Appl. No.09/942,628  
Amdt. dated June 21, 2005  
Reply to Office action of March 22, 2005  
Atty. Docket No. AP1102US

**Amendments to the Drawings:**

### REMARKS/ARGUMENTS

**FIG. 4**

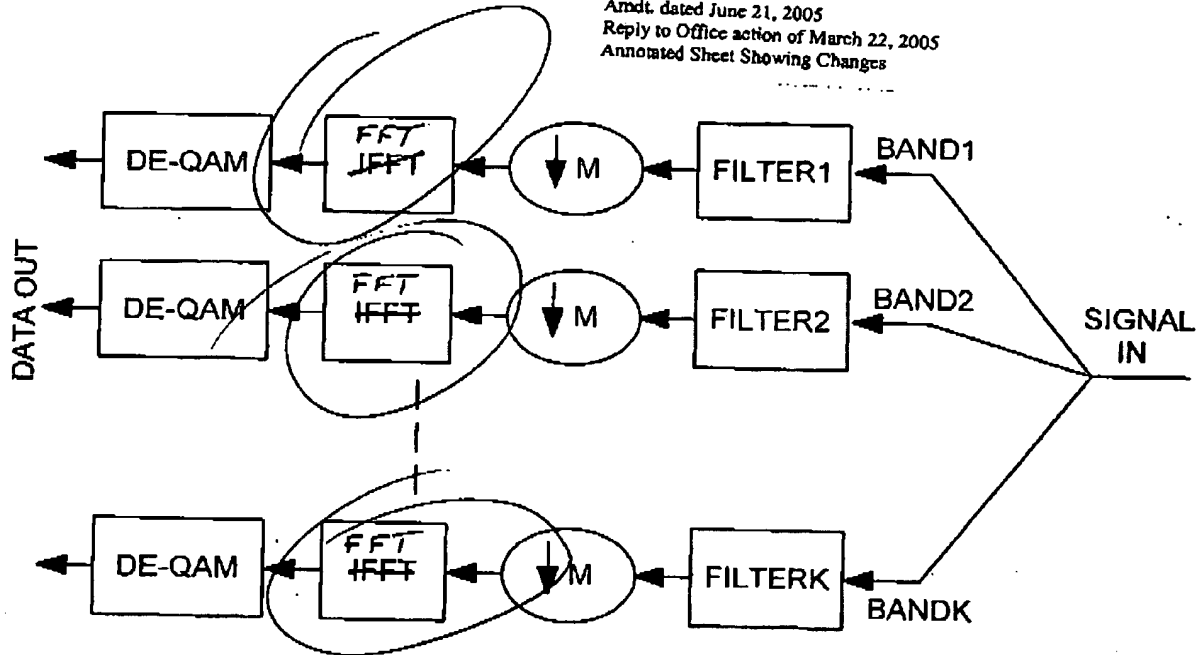
The replacement sheets of drawings include changes to Figures 4, 6 and 7. These sheets, which include Figures 4, 5, 6, 7 and 8, replace the original sheets which included Figures 4, 5, 6, 7 and 8. In amended Figure 4, the three occurrences of "FFT" have been changed to "IFFT". In amended Figure 6, the three occurrences of "IFFT" have been changed to "FFT".

The amendments to the drawings correct the labelling of the FFT and IFFT units which had been transposed in original Figures 4 and 7.
